PROJECT TITLE
80 E
OLENTANGY
POWELL, OHIO 43065

PROJECT NO. SJM_2010
ISSUE FINAL P&Z APPLICATION
ISSUE DATE 04.21.2021
SHEET TITLE

Gretchen Bonasera is proposing to renovate and expand the current building, converting the existing home to a private social club featuring rare bourbons, fine wines, and chef inspired cocktails with just enough small plates of food served to imbibe responsibly. We anticipate our club to be used as a place to gather for business or social, and to be a great place to come before or after dinner plans at one of the great local restaurants Powell has to offer.

The purpose of this document is to address comments from previous meetings and/or staff reports from the City of Powell Planning Staff, the Historic Downtown Advisory Commission and Liberty Township Fire Dept...

1 SITE LIGHTING
A8.03 1" = 10'-0"

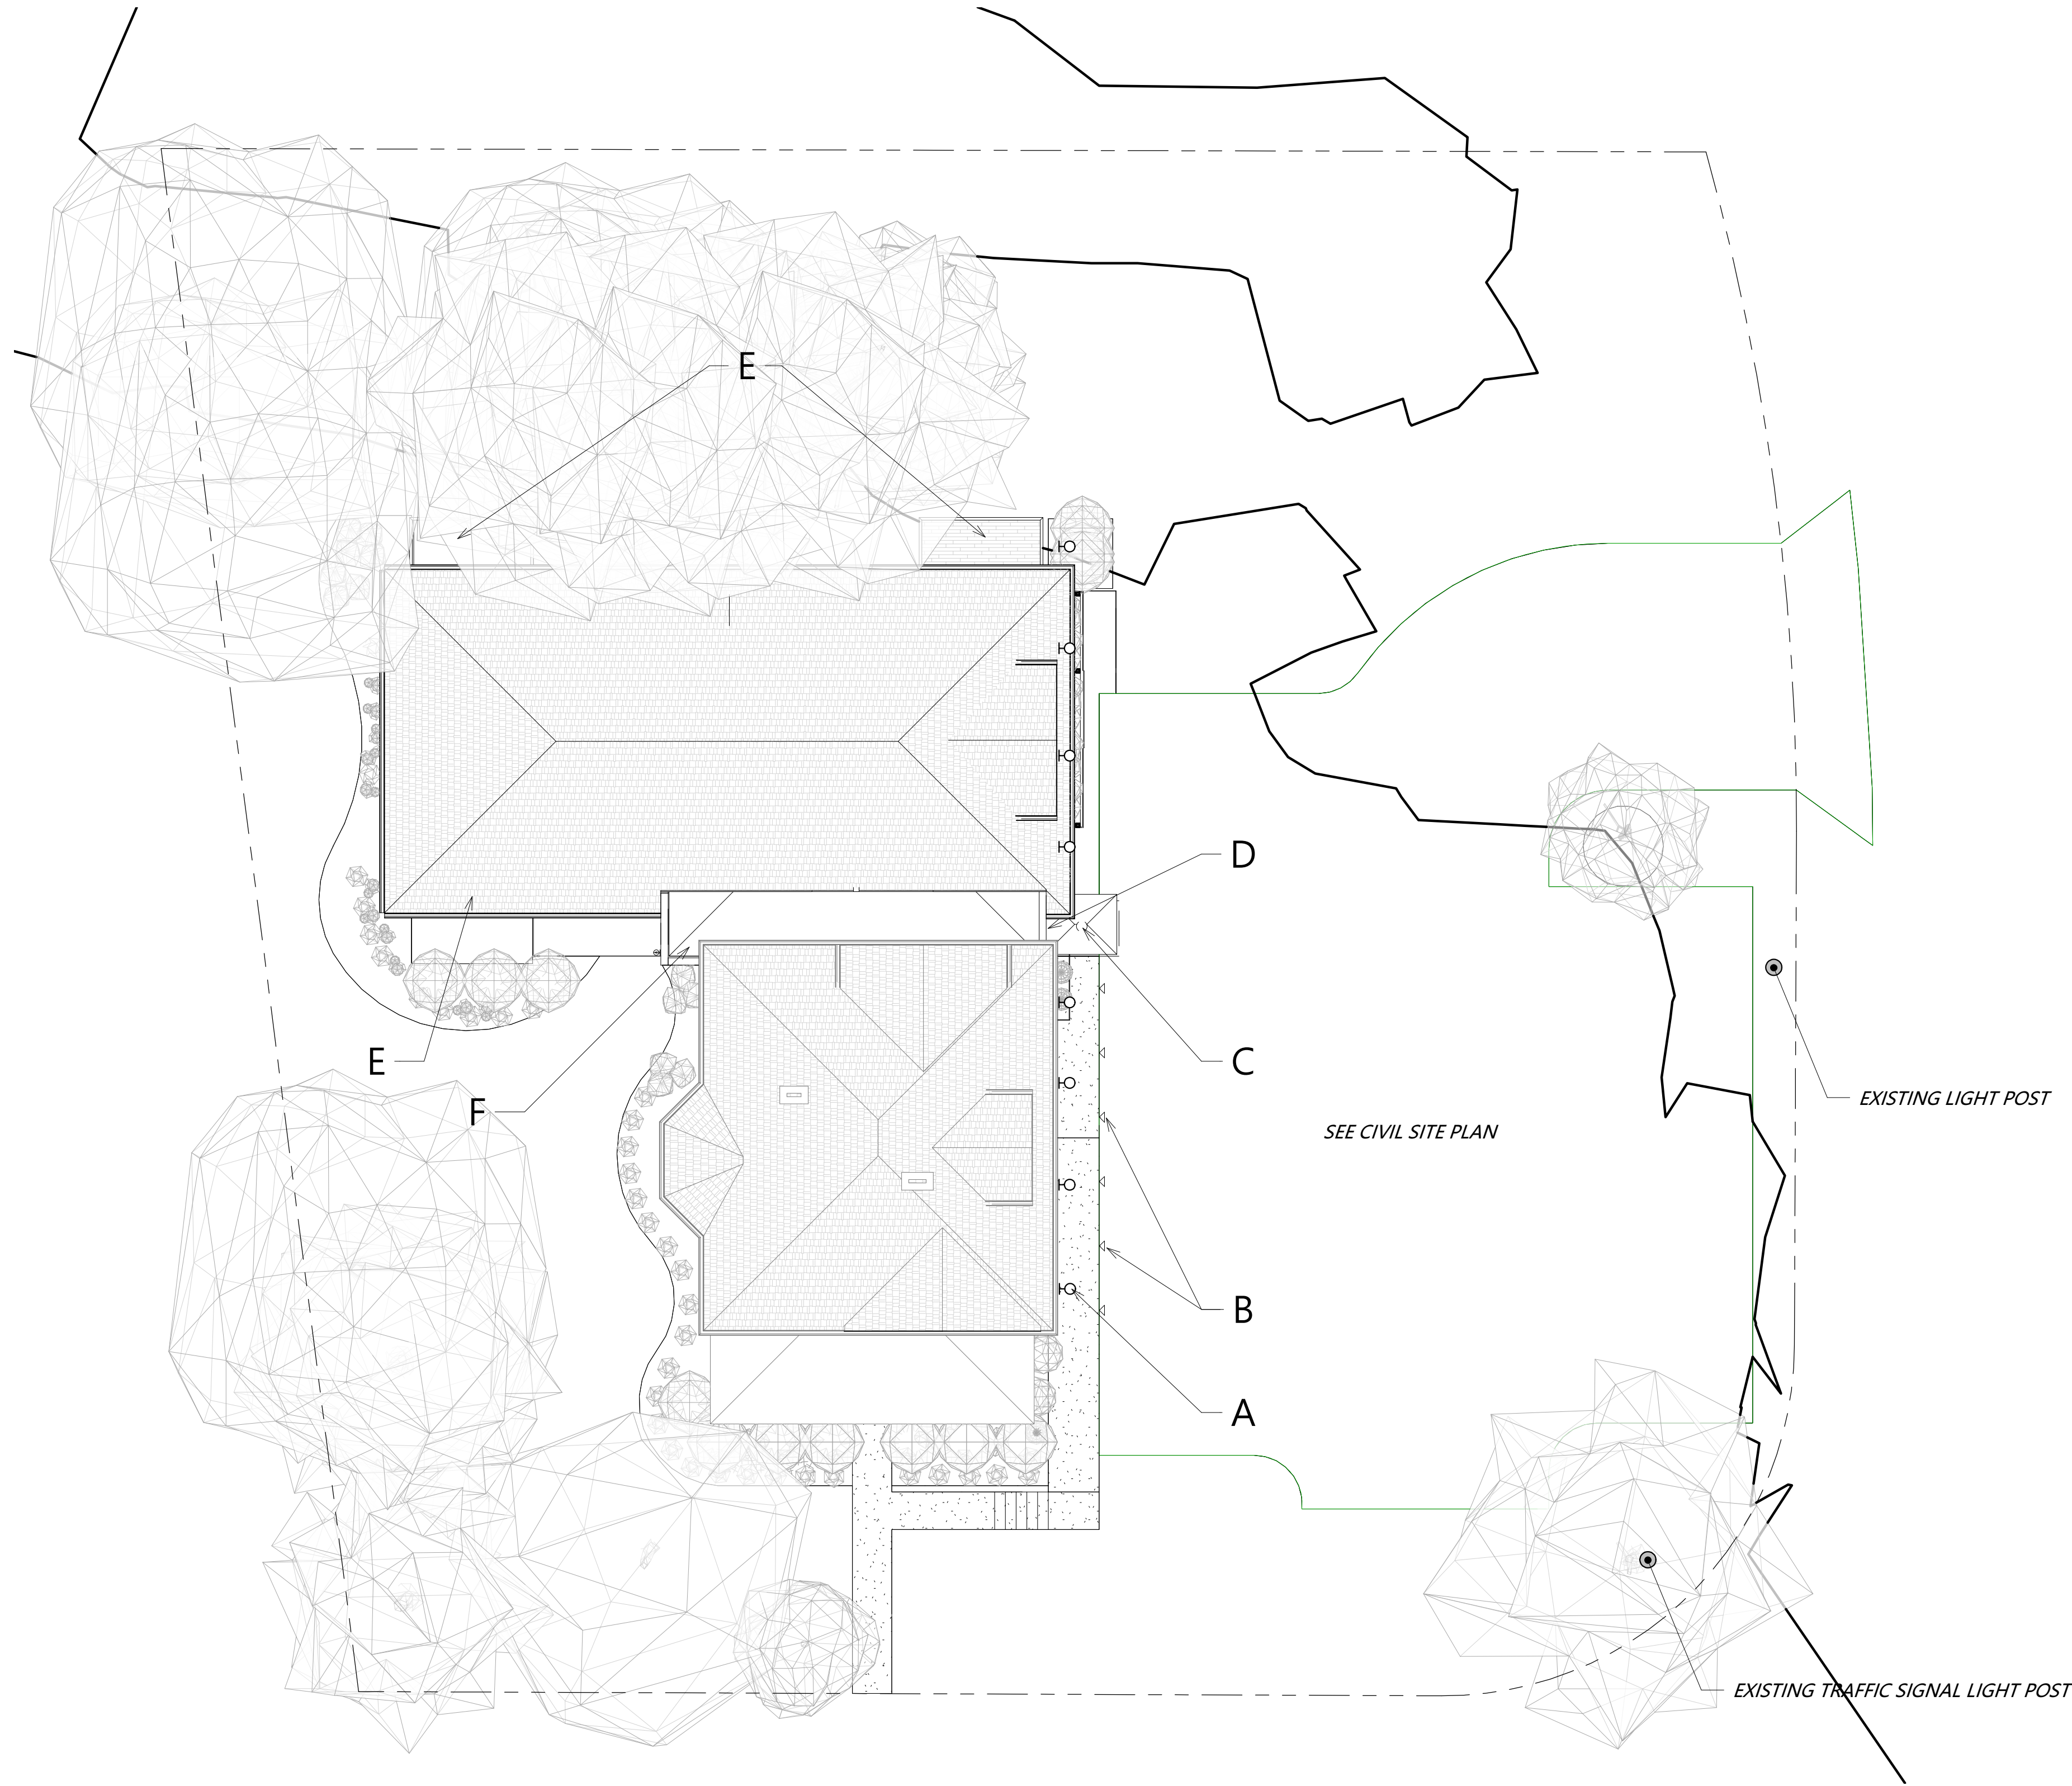
Staff Comment: Additional exterior lighting will help to create a safer environment for customers and employees. The freestanding path lighting meets the architectural guidelines, but the wall sconces are more modern than the guidelines suggest.
